**RE: MINOR CHANGE REQUEST TO DEVELOPMENT PERMIT FOR MATERIAL CHANGE OF
USE FOR A WAREHOUSE – MCU/2022/525**

AT: 28 EASTRIDGE STREET, STAPYLTON QLD 4207 – LOT 117 ON SP316137

This change application seeks to amend the existing Warehouse approval by converting the single Warehouse into three separate Warehouse tenancies. The proposed changes are minor in nature and are consistent with the minor change requirements under the Planning Act 2016.

Figure 2: Proposed site layout (GDP File, 2024)

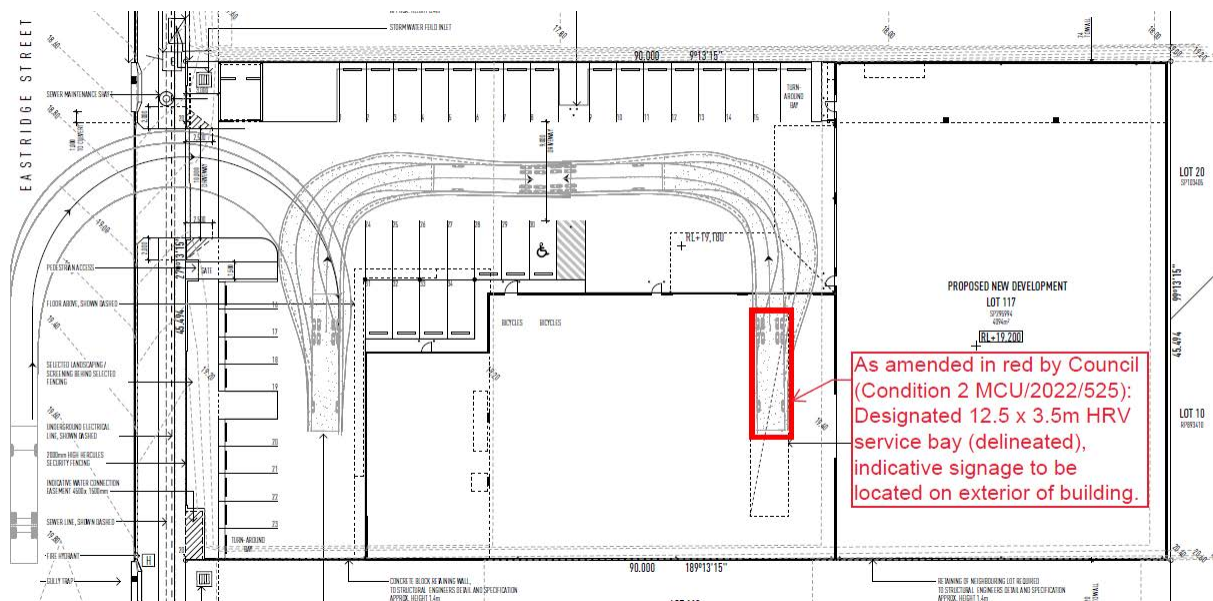
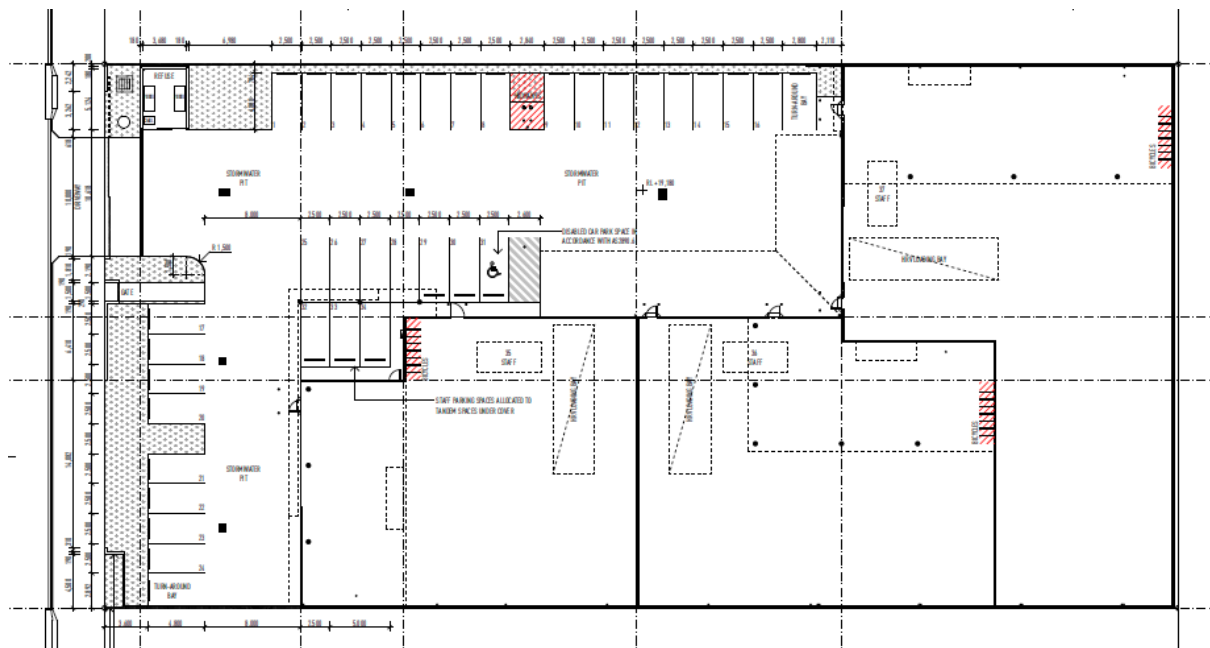
This application proposes to amend the existing Warehouse approval by converting the single Warehouse into three separate Warehouse tenancies. The changes are sought in response to current market conditions whereby this smaller industrial footprint is more readily sought than a single tenancy.

The internal layout of the existing Warehouse is to be reconfigured into three separate tenancies. Each tenancy will have Warehouse space at ground level, with an ancillary office and storage at mezzanine level. An extract of the proposed site layout is shown in in **Figure 2** below. A copy of the amended proposal plans is provided within **Appendix D**.

As a result of the proposed changes, the development is required to provide a total of 38 parking spaces. The development provides 37 parking spaces, which is marginally below this requirement. The existing carparking layout will remain largely unchanged but will be altered slightly to fit the additional parking spaces. 34 parking spaces will be located externally, with three parking spaces located inside each tenancy (one per tenancy - reserved for staff). In addition, bicycle parking is provided within each tenancy at a rate of eight bicycle parking spaces per tenancy.

With regard to site servicing, the development provides for a Heavy Rigid Vehicle (HRV) loading bay within each tenancy. The original approval allowed for HRV servicing in lieu of Articulated Vehicle (AV) servicing given the size and shape of the site does not allow for full-on-site manoeuvring for an AV (noting that allowance for restricted manoeuvring for AVs will be maintained in accordance with the original approval). This arrangement will be maintained under the proposed minor change. Swept paths for HRV manoeuvring are shown on the amended proposal plans.
